COMMENTS FOR VALLCO SHOPPING DISTRICT SPECIFIC PLAN DEIR

Draft Environmental Impact Report

SCH# 2018022021

Figure 4: DEIR Heights

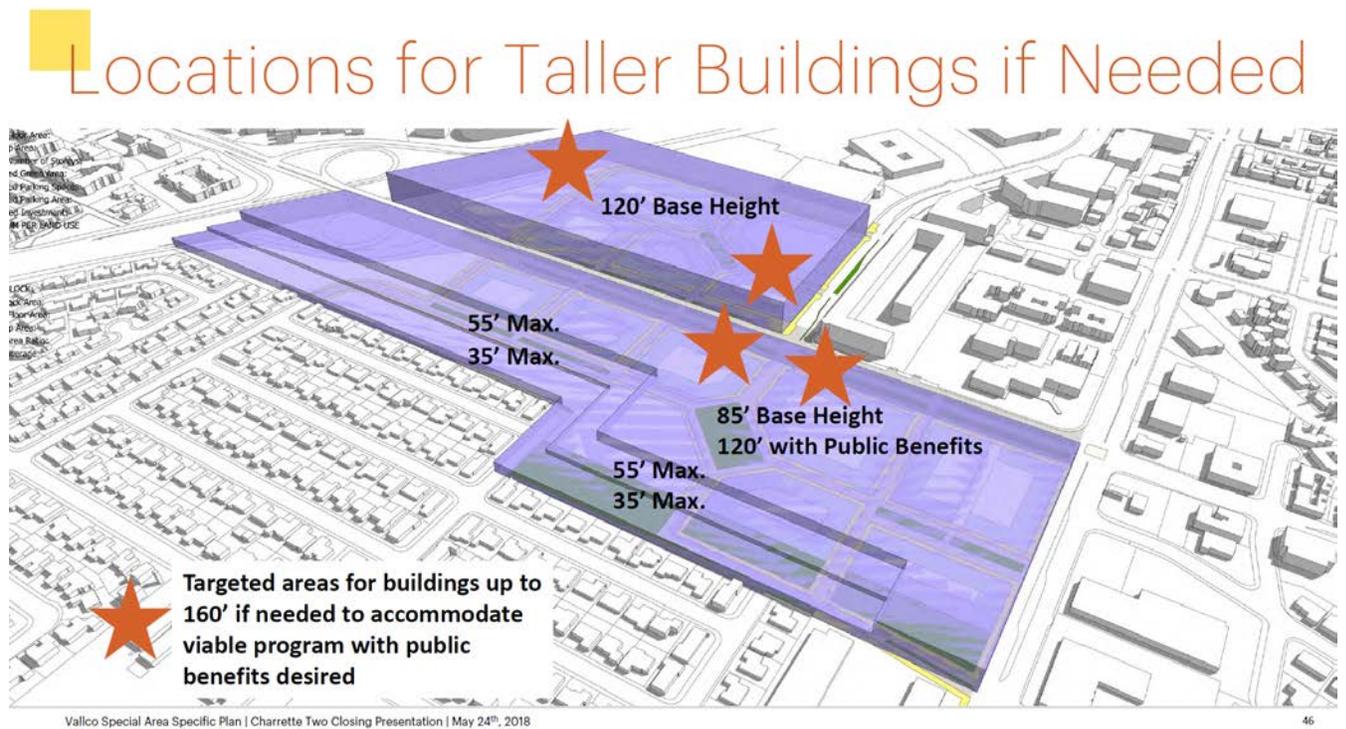
4. To add to the confusion as to what the project may end up being, the maximum height was also shown to be 294'. These height differences will cause different shadow and intrusion issues, such as privacy intrusion into Apple Campus HQ which may be a security risk at the corporate headquarters, guest discomfort at the outdoor swimming pool at Hyatt House, and the lack of privacy for the area homes and back yards. In Section 4.2.1 of the DEIR, heights are shown up to 165'.

Figure 10: Section from SB 35 Vallco Application

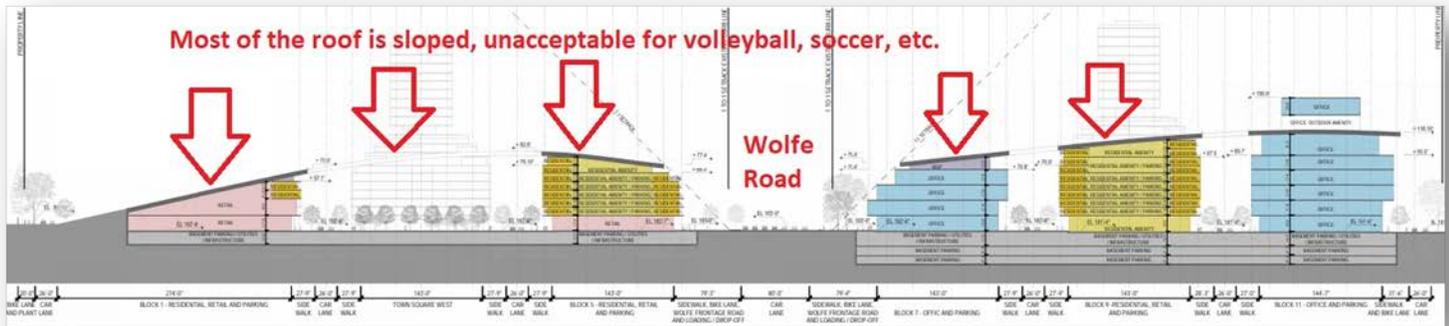
The 30 acre green roof is not park land acreage per the Municipal Code. While it may be considered a recreational area, the uses of such space are limited. Here is a cross section of the SB 35 plan roof:

Figure 25: AQI from BAAQMD

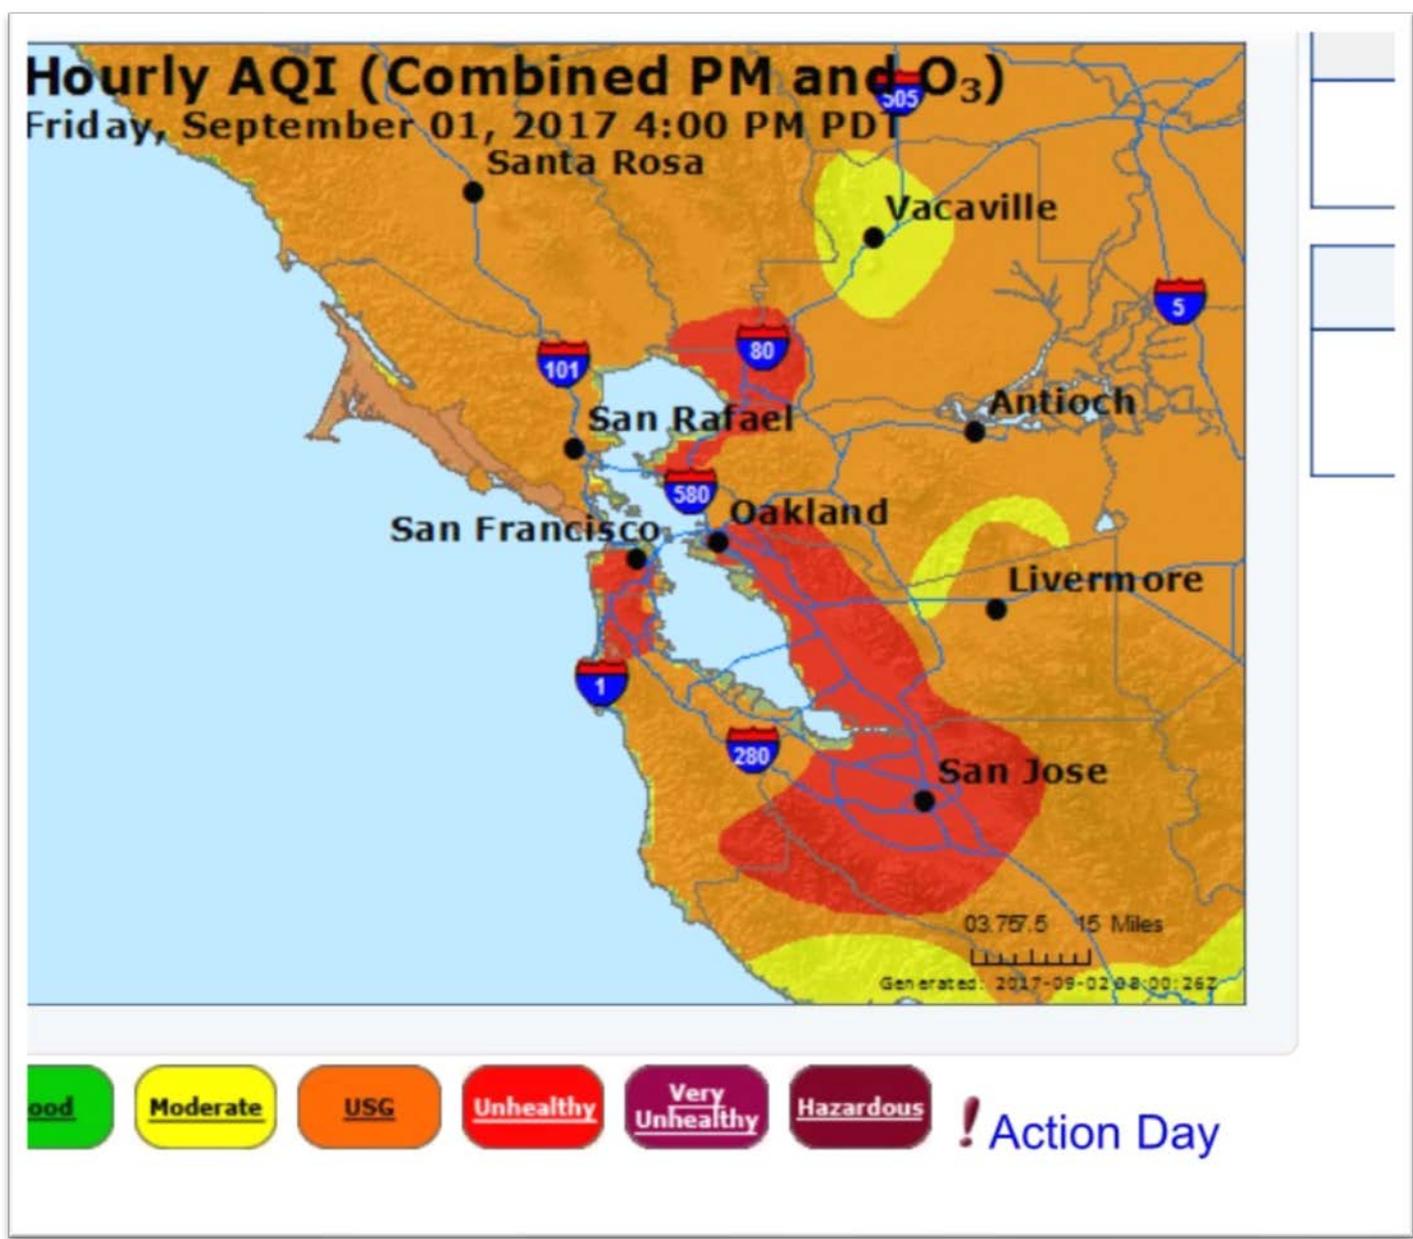
The cancer risk assessment is based on erroneous traffic studies and the air quality monitoring stations had old data from 2013 and/or were too far away to use data. The cancer risk needs to be recalculated. The amount of exposure time should reflect seniors not leaving the project area. The baseline air quality monitoring must be taken over an extended period with particular attention paid to the summer months when Ozone levels increase. Here is an example day when children would be playing outdoors, Ozone was the primary pollutant. Note these are regional amounts, and the increases along the freeways are not shown:

The I-280 freeway produces substantial TAC pollutant concentrations and the south bay is subjected to the entire bay area's pollutants which are converted to Ozone in the warm summer months. The DEIR failed to monitor air pollution for the site for any time period, and only modeled pollutants onsite. Fires are expected to be the new normal, bringing potential further impacts to the region's air quality.

Figure 42: Opticos Charrette #2

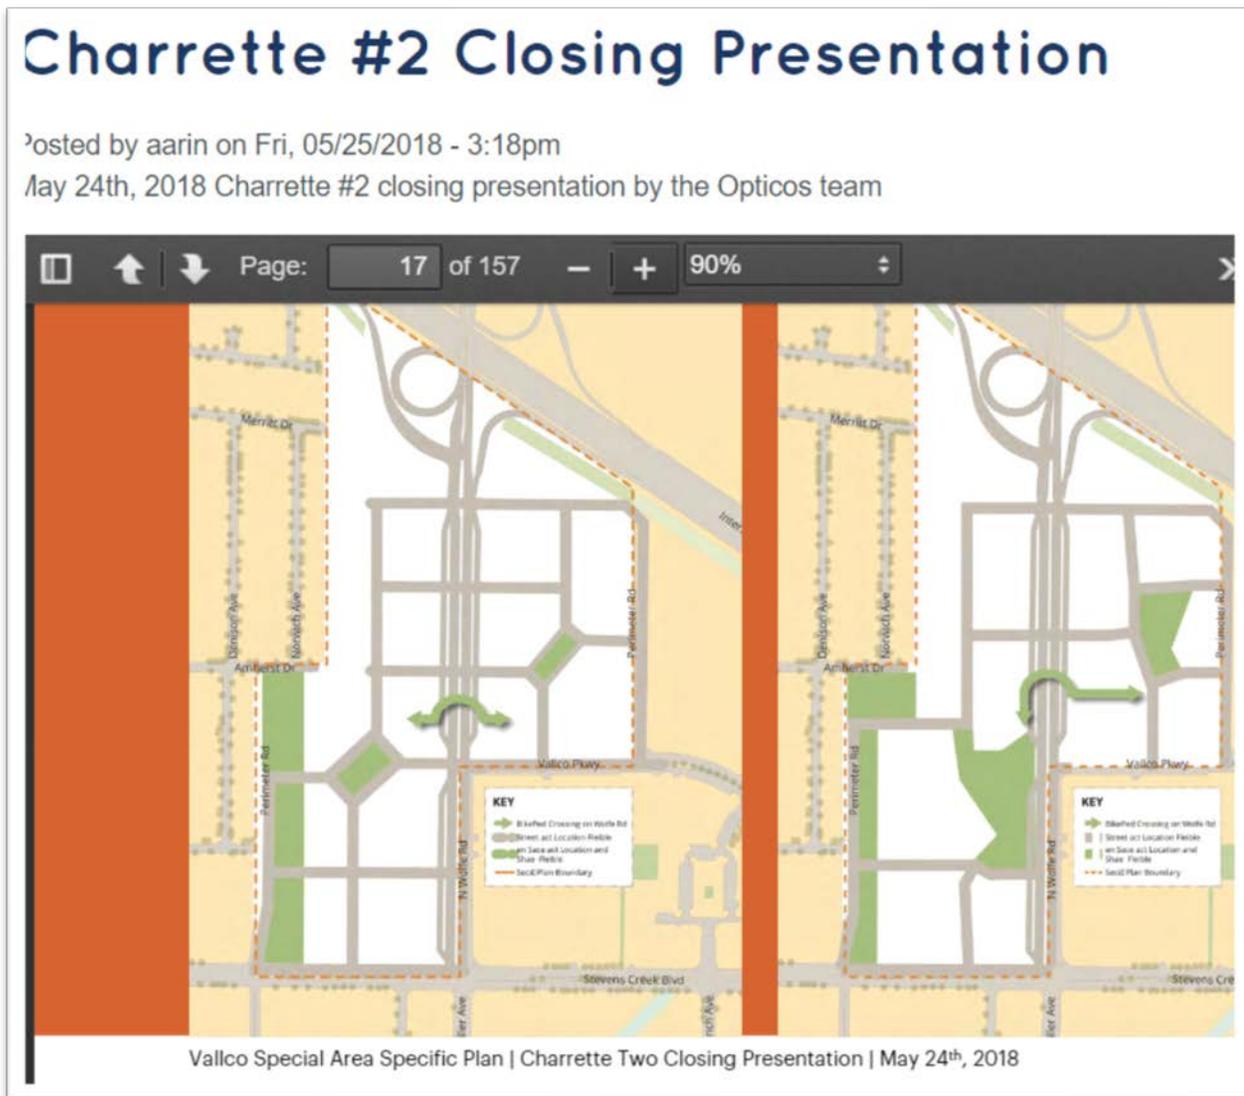
Charrette #2 Closing Presentation shows parks adjacent to back yards of single family residences. This may, combined with Perimeter Rd. noise exceed Municipal Code permissible sound levels. The DEIR does not adequately address this.

FIGURE 3.13-2

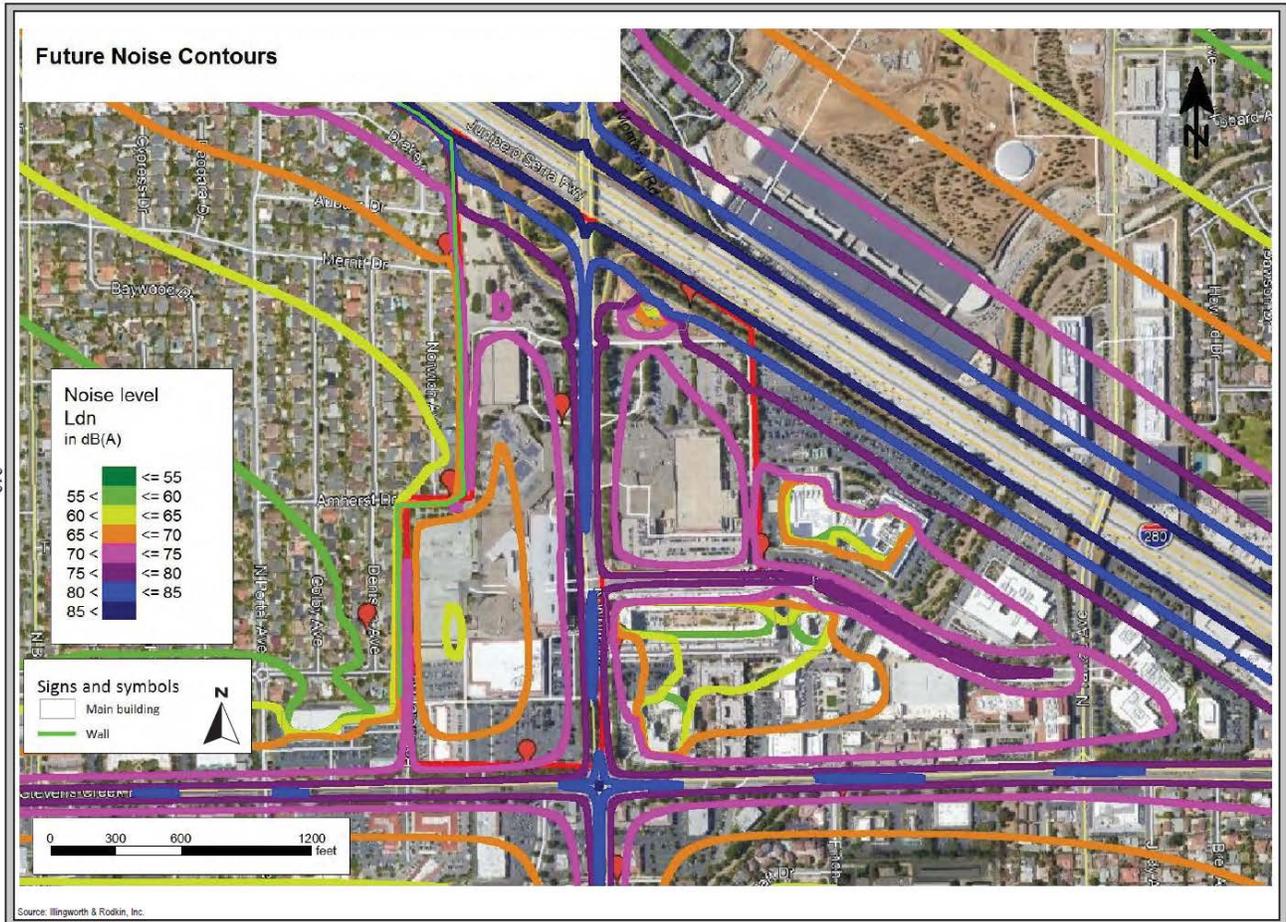
The Future Noise Contours map has some omissions regarding noise from the Perimeter Road, western edge park, and proposed amphitheater. The map has gross assumptions regarding what the plan would look like and ignores conditions on the roof which would result in a separate layer of mapping: One layer for ground level (ear level) and one level for the roof park to see if it meets park noise requirements.

The future noise contours for the project site exceed residential maximum levels according to the Cupertino Municipal Code 10.48.040.

Figure 52: Sample of local advertising showing higher employees per 1000 SF than studied

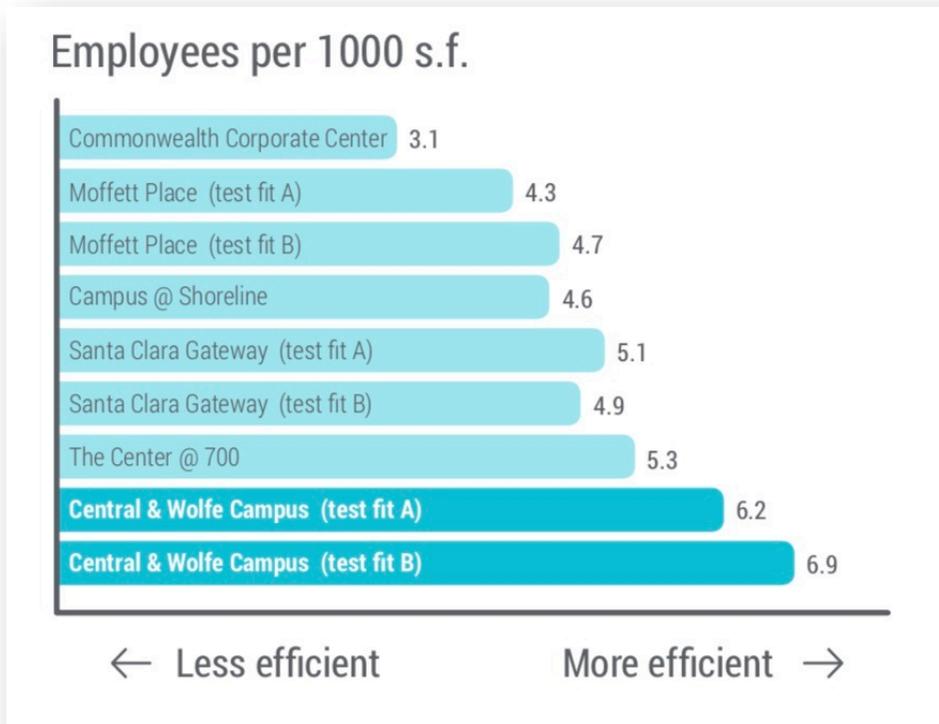
It is unclear, given that Apple Park has been occupying, how their (Apple Park) traffic has been assigned. For instance, there were traffic counts in May, 2017 which would reflect thousands of trips by construction workers to the site which would likely have been coming from the I-280 and east bound AM and westbound PM. There were also traffic counts in January, 2018, which would perhaps now show a few hundred Apple tech workers who would presumably be coming from other areas along with continued construction workers. As of March, 2018 approximately 6,000 employees were at Apple Park out of the expected 14,200. There have been many requests of the city to wait until Apple Park fully occupies to perform traffic counts. Main Street Cupertino was also under construction during May, 2017 and those construction workers would also be impacting the counts. There have been several intersections under construction, including the Calvert/I-280 project and Lawrence Expressway/I-280 exit project. These multiple projects have rerouted traffic and altered the makeup of drivers into artificial patterns not reflected in the study. What the traffic counts show, is what the area traffic is like with major construction underway.

Traffic impacts, while significant and unavoidable with mitigation is underestimated.
